# Objections to Amended DA listed on 26/4/2022

**Lot 2 DP 514296  
At 7 Crown Rd Queenscliff.**

**Objection submitted by:  
Dr Anthony Burns  
Mrs Stone Burns  
02 99054517  
1 Crown Rd Queenscliff**

Fig 1a

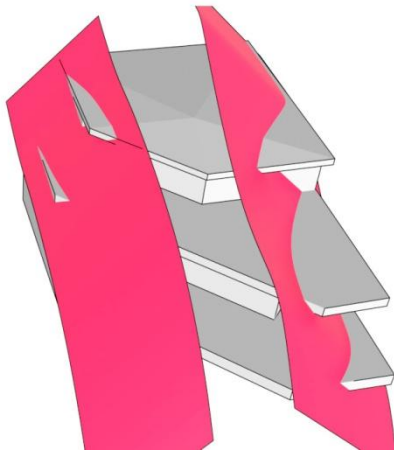
- The East wall existing doorway is now shown ... hanging in space, 1.24 m above the path beneath it. Similarly the claimed ground level does not reflect the survey, or reality. Regardless, the East side height non compliances are now much more clearly shown in our new 3D height plane drawings 1a and 1c. Our 3D height planes are based **only on survey points from the DA's survey plan**. They do **not** use fake points and invented levels. They show clearly the height non compliances with Side Boundary Envelope and Maximum Wall Height at the East side of the top level in the DA.

2. The Side Boundary Envelope should be based on the Existing Ground Level using the DA's survey plan, as shown in Fig 1a and Fig 2. The Existing Ground Level on the East side is identical to the "natural" ground level because there has been no excavation of the natural rock shelf. We have used the survey point RL 30.77 on top of the path, shown in the DA's survey. **We request that the East wall on the top level should be 3.80m from the boundary** as we previously described, rather than the amended DA's 3.04m.

The Northern extent of the roof has a large and extensive non compliance with the Maximum Building Height, Side Boundary Envelope, and Maximum Wall Heights (a 2.19 m height non compliance), as shown in Figs 1a, 1b, 1c. These are based on the LEP 2011's Existing Ground Level, taken **directly from the DA's survey plan**. These non compliances cause view loss.

Fig 1b

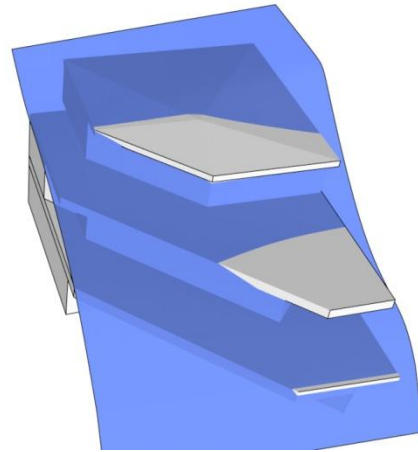
Fig 1b shows large and extensive non compliances with the Maximum Building Height. The DA proposes to increase building height by 550mm. The clause 4.6 submission provides no basis for varying the requirement of a Maximum Building Height of 8.5m. Please see “Objection to Clause 4.6 Submission.” below.

The claimed maximum building height plane is vastly in error. The maximum building height planes based on the DA survey data are shown in Fig 1b. Height non compliances are very large.

Our 3D height planes in Fig 1b show large and extensive non compliance with Maximum Building Height. Our 3D model is based on DA’s own survey points of existing ground levels, not some arbitrary values as in the 4.6 submission.

Fig 3a

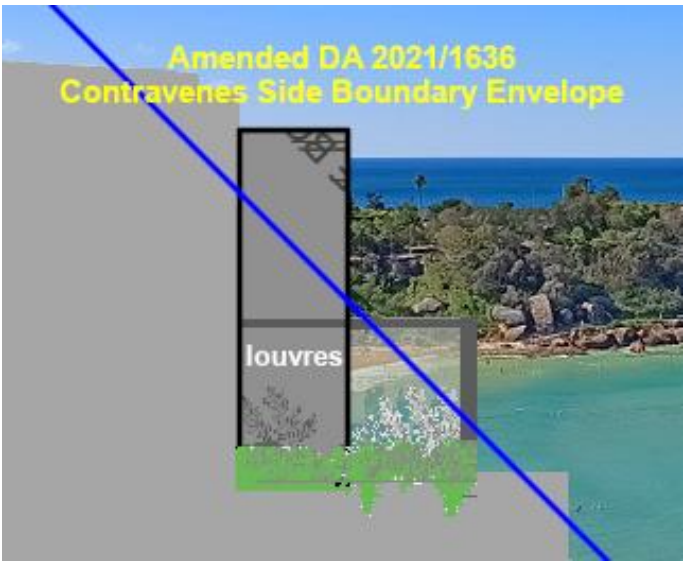
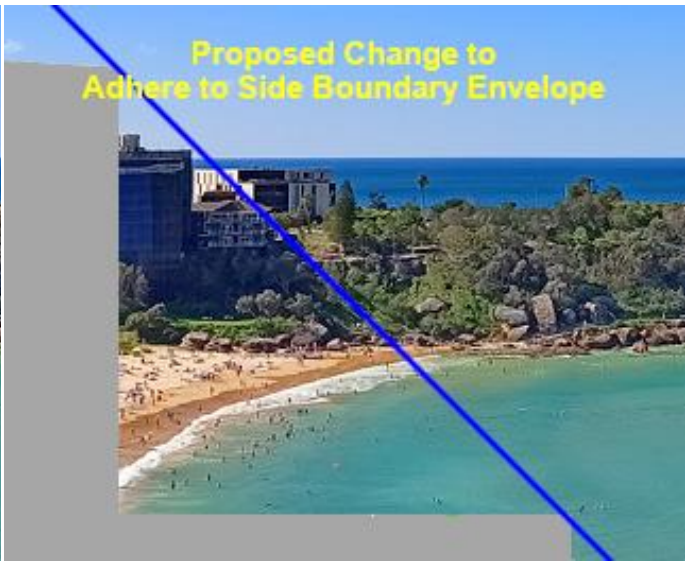
3. This increase of just 0.76m from 3.04m in the DA, involves a reduction in area of the DA of 4.47 sq m. This is trivial compared to the proposed increase in area of the DA of 170 sq m. However, it has a large impact on our view loss from every level of our home as can be seen in Figs 3a, 3b (lower level view loss).

## Landscaped Area

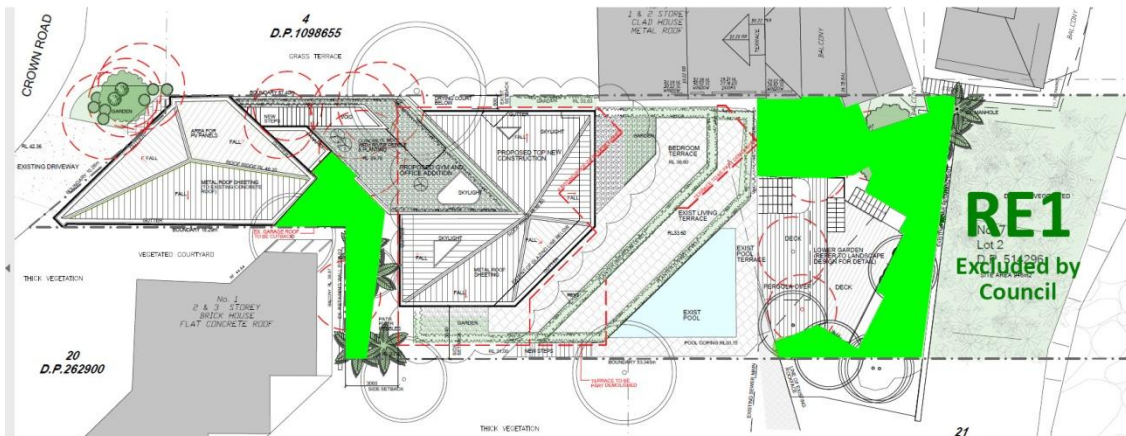
DCP Control D1 Requires a minimum 40% landscaped open space is to be provided. The landscaped area of the DA is **17.5%**. **This is less than half** the required minimum of 40%. **This is a direct result of the excessive bulk of the proposal.**

The green area shows landscaped area. Both of these areas include dimensions less than 2 metres and according to the DCP should be excluded. This would imply 0% landscaped area. If they are included, the landscaped area is 17.5%. Note that vegetation in planter boxes is not permissible.

### 5.1.7 Front Set Back

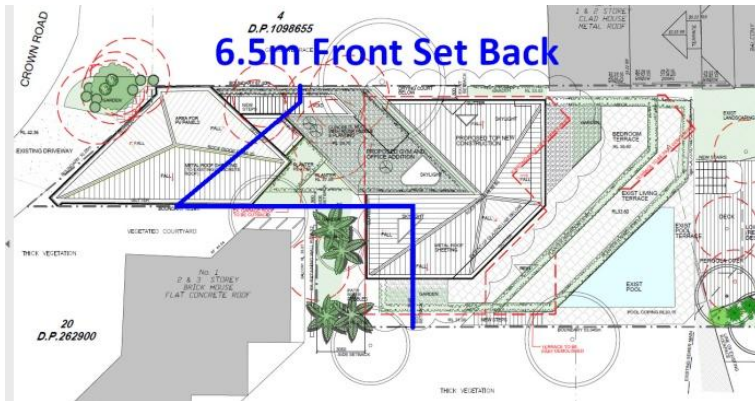
The DCP front boundary set back should be 6.5m. SEPP 3.10 (15) Minimum setbacks: "... must have a setback from the rear boundary of the lot that is in front of the battle-axe lot ... ". That is, the part of the building in front of our property should be 6.5 metres from the boundary. The amended DA has reduced the existing set back of 3.8m to a proposed 3.06m. Reducing the distance between buildings causes loss of light by ambient occlusion, together with a feeling of increased oppressive crowding.

The DA is non compliant.
